Certified Action of the City of Raleigh Planning Commission

Case File / Name: SP-44-12 / Family Dollar Store Rock Quarry Road

Staff Report

SP-44-12 / Site Plan

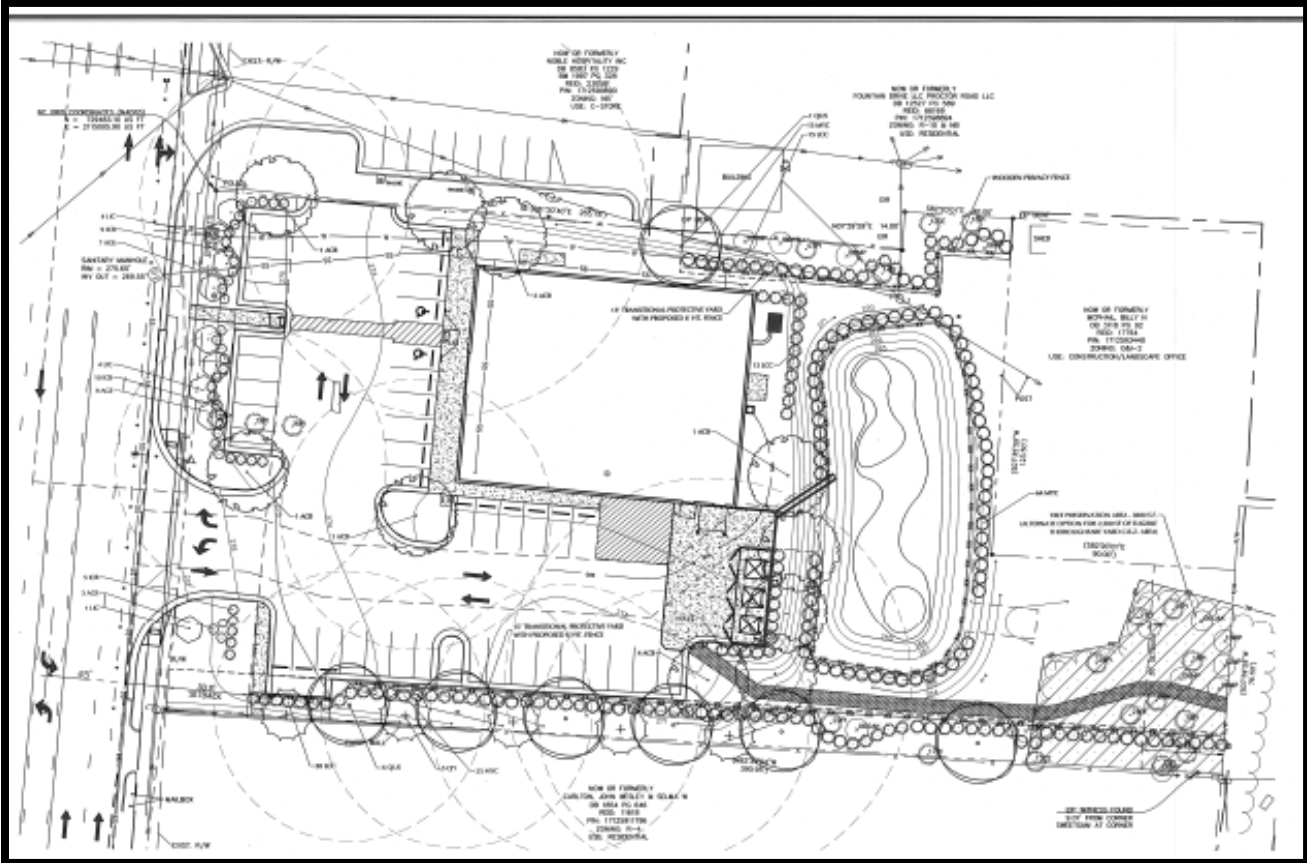
Key Issues: An alternate means of compliance is being requested from providing a 30' Type B Transitional Protective Yard along the northern and southern property lines.

An alternate means of compliance from Code Section 10-2132.2(b)(20) not providing a 50' Natural Protective yard along a Thoroughfare.

VARIANCES / ALTERNATES: An alternate means of compliance is being requested from providing a 30' Type B Transitional Protective Yard along the northern and southern property lines. The alternate proposed is a 15' in width yard with the construction of a six-foot wooden fence and 1 tree planted every 20 linear feet and 1 evergreen shrub planted 5 feet on center.

Comment	Response
The Commission is concerned about mulch being used in the pedestrian path (rear of building). The Commission recommends that more attention and detail should be given to the path; clients should consider using different material for path outside of the tree conservation area.	A timber lined path with a series of single steps
The Commission recommends using additional plantings to the parking lot and front side of building	19 Dwarf Buford Hollies and 3 Chinese Witch Hazel shrubs were added to the interior of the site.
The Commission recommends the continued use of brick on the side elevations of the building. While the Commission would prefer the use of brick for the entirety of the side elevations, it should at a minimum extend to the transitional protective yard fence and landscaping on the north side of the building and the rear of the parking area adjacent to the building on the south side.	Brick was added to the side elevations and makes up about 75% of the façade. Split –face CMU base, accent stripe. Canopies and glazed store front expressions on both side walls were added.

- (1) That the Planning Commission finds that this site plan meets the standards for approval of Code Section 10-2132.2(d);
- (2) That an alternate means of compliance in accordance with 10-2082.4 is approved from providing a 30' Type B transitional protective yard along the northern and southern property lines. The alternate is a 6' closed wooden fence and a 15' in width transitional protective yard along the property lines. 1 tree will be planted every 20 linear feet with evergreen shrubs planted 5' on center;

- (3) That in accordance with Code Section 10-2132.2(d) the Planning Commission approve the provided tree conservation measures on site;
- (4) That an offer of cross access to the property to the north owned by Noble Hospitality and described in DB 08583 PG 1229 826 and to the south owned by John Wesley and Selma Carlton and described in DB 01854 PG 0646 be recorded in the Wake County Registry, and that a recorded copy of this offer of cross access easement be returned to the Planning Department; Upon acceptance of the adjacent property, that the Family Dollar site will be responsible for removing the existing fence areas and provide any pavement necessary on their site to allow for the connection;

- (16) That construction plans for public improvements be approved by the Public Works Department;
- (17) That a revised landscape plan be submitted relocating the shrub plantings outside the tree conservation area;
